VIRGINIA ELECTRIC AND POWER COMPANY
SURRY POWER STATION UNITS 1 AND 2
LICENSE AMENDMENT REQUEST - APPLICATION OF RISK-INFORMED
APPROACH FOR TORNADO CLASSIFICATION OF THE FUEL HANDLING
TROLLEY SUPPORT STRUCTURE
SUPPLEMENTAL INFORMATION

RESPONSE TO NRC REQUEST FOR SUPPLEMENTAL INFORMATION

APPLICATION OF RISK-INFORMED APPROACH FOR TORNADO
CLASSIFICATION OF THE FUEL HANDLING TROLLEY SUPPORT STRUCTURE

Virginia Electric and Power Company
(Dominion Energy Virginia)
Surry Power Station Units 1 and 2

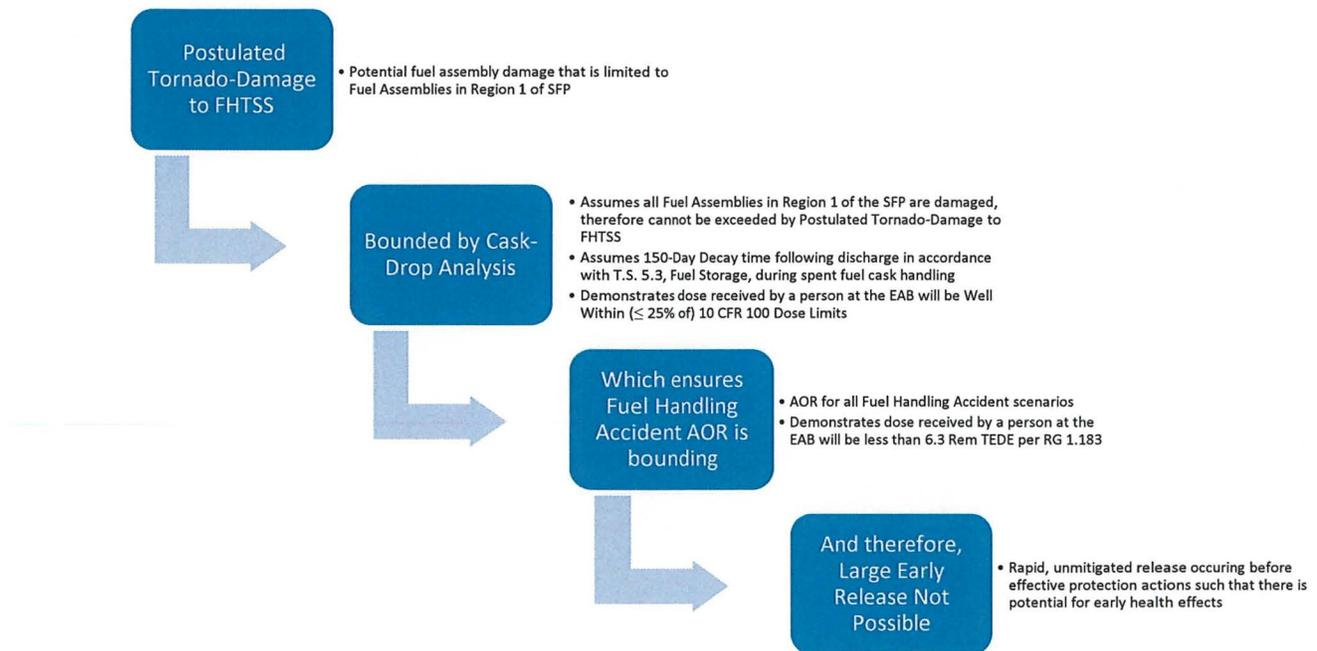
- 1. A justification for the statement that a potential release resulting from spent fuel damage is expected to be bounded by the fuel accidents analyzed under the design basis, including the cask-drop and fuel handling accidents. For this item, the licensee needs to include: (1) a description of the accident scenarios and radiological conditions considered when evaluating a potential radioactive release resulting from*

tornado wind damage to the FHTSS, and (2) a description of the methodology and results of the analysis demonstrating that a potential radioactive release resulting from tornado wind damage to the FHTSS is bounded by the failure of all 324 fuel assemblies stored in the first three rows of storage racks adjacent to the cask loading area.

Civil/structural assessment concluded spent fuel damage resulting from falling structural members of the FHTSS was limited to Region 1. Because the spent fuel cask drop accident radiological dose analysis assumes all 324 assemblies in Region 1 are damaged, the extent of spent fuel damage and radiological dose consequences resulting from a spent fuel cask drop accident were concluded to bound those associated with FHTSS structural failure. The dose consequences of the cask drop accident analysis are, in turn, bounded by the FHA analysis of record (AOR). The FHA analysis demonstrates the dose consequences at the exclusion area boundary (EAB) meet the acceptance criterion of 6.3 Rem TEDE, per Regulatory Guide 1.183. As described further in the response to NRC Request No. 2, the radiological consequences of an FHA are much less than those associated with a Large Early Release, defined by the PRA standard¹ as “the rapid, unmitigated release of air-borne fission products from the containment to the environment occurring before the effective implementation of off-site emergency response and protective actions such that there is a potential for early health effects.” Additional background on supporting evaluations is presented below.

FHTSS structural failure is postulated to result in the structure partially or fully collapsing. In the worst-case, both ends of structural members may detach from the FHTSS and fall into the SFP, thereby impacting stored spent fuel assemblies or the SFP walls or mat. SFP inventory and fuel cooling integrity are maintained in this scenario because falling FHTSS members do not have enough energy to perforate the reinforced concrete SFP structure, and the fuel cooling components are not located where they could be impacted by falling members. Since SFP leakage and/or loss of cooling aren't credible, the dose consequence evaluation is limited to direct damage caused by falling members that impact spent fuel assemblies. This scenario could release gaseous fission products from the fuel rods into the fuel building; however, fission products contained in the fuel pellets would not be released since decay heat removal is not at risk of being lost.

The yellow highlighted area of Figure 1 shows the area of concern known and referred to as the “High Bay”. The blue highlighted area shows the area SPS defines as “Region 1” of the SFP. Based on civil and structural assessment, any postulated failure of the High Bay caused by a tornado would result in limited damage, if any, to spent fuel assemblies, and any damage to spent fuel is assessed to be limited to only Region 1.

The SPS cask-drop analysis assumes every spent fuel assembly in Region 1 of the SFP is damaged. It is not credible to damage more fuel as a result of tornado damage to the FHTSS than is assumed in the cask-drop analysis.
